UNITED STATES PATENT AND TRADEMARK OFFICE

APPLICATION NO.	FILING DATE	FIRST NAMED INVENTOR	ATTORNEY DOCKET NO.	CONFIRMATION NO.
10/801,273	03/16/2004	Jaime E. Garcia	JK01488A	2972
28368 7590 05/04/2009 THE BLACK & DECKER CORPORATION 701 EAST JOPPA ROAD, TW199 TOWSON, MD 21286				
EXAMINER LANDRUM, EDWARD F				
ART UNIT		PAPER NUMBER		
3724				
MAIL DATE		DELIVERY MODE		
05/04/2009		PAPER

Office Action Summary

DETAILED ACTION

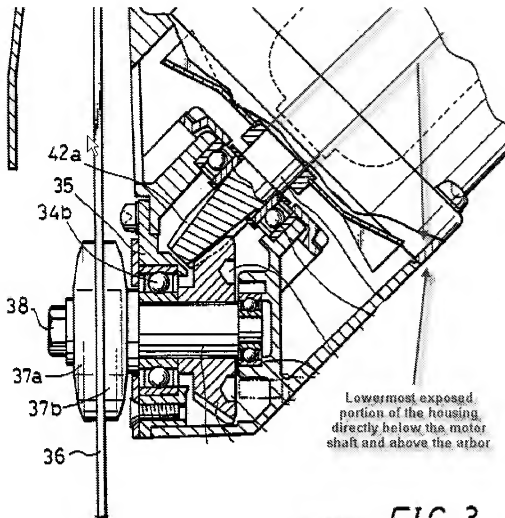
2. Claims 1-7, 34, and 35 are rejected under 35 U.S.C. 112, second paragraph, as being indefinite for failing to particularly point out and distinctly claim the subject matter which applicant regards as the invention.

Based on Figure 6 and the claim language related to the gear housing and the raised and lowered positions of the cutting assembly it is not understood how the portion of the gear housing that is directly below the motor shaft (644P) is always above the arbor. If the device were beveled 45 degrees counter clockwise from the position shown in Figure 6 the lowermost exposed portion of the housing directly below the motor shaft would no longer be above the arbor. Furthermore, what portion of the motor shaft is the lowermost portion of the housing directly below of?

Modified Figure 2

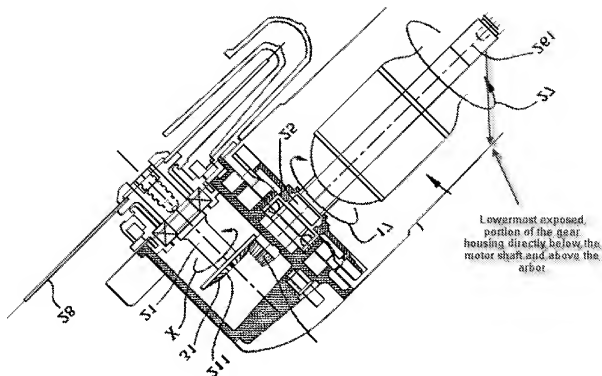
Replacing gear and motor configuration of Hurn in combination with Ito still teaches the limitation of an outer lower most exposed portion of the gear housing being directly below the motor shaft closest to a support surface and above the arbor See modified Figure 2 of Hurn below. The Figure has been reversed and rotated 45 degrees clockwise, which is a possible lowered position of the cutting assembly.
